## 1 Products affected

Product Change Notification					FEC material, design and packaging change		
owner	creation date	release date	released by	change order	rev	page	D10-066-072
kraftal	22.06.2022	12.10.2022	schulejo	2022099	A	1 of 2

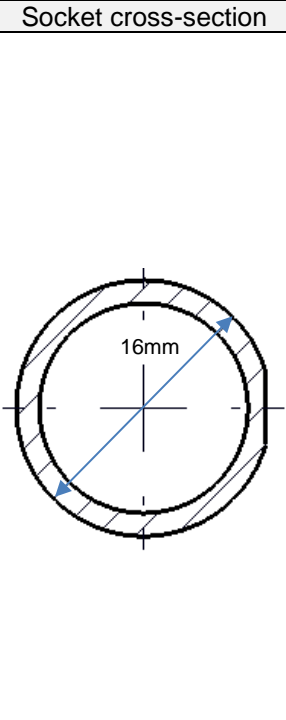
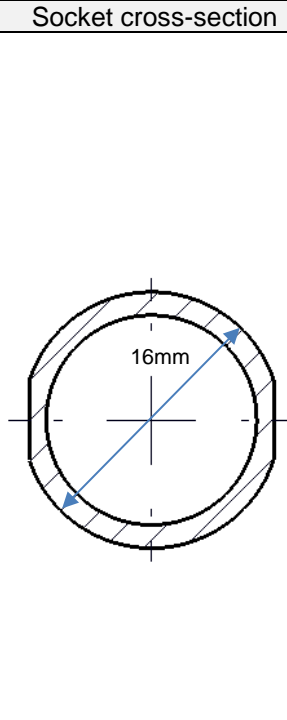
Current plastic material		New plastic material	
Thermoset PF-GF/MF FR		Thermoplastic PPA-GF FR	
Current product appearance		New product appearance	
ISO view	Socket cross-section	ISO view	Socket cross-section
		 marks/logos moved by 90°	
Current product packaging dimension		New product packaging dimension (0031.1622 only)	
cardboard box 194 x 102 x 120 mm		cardboard box 259 x 84 x 154 mm
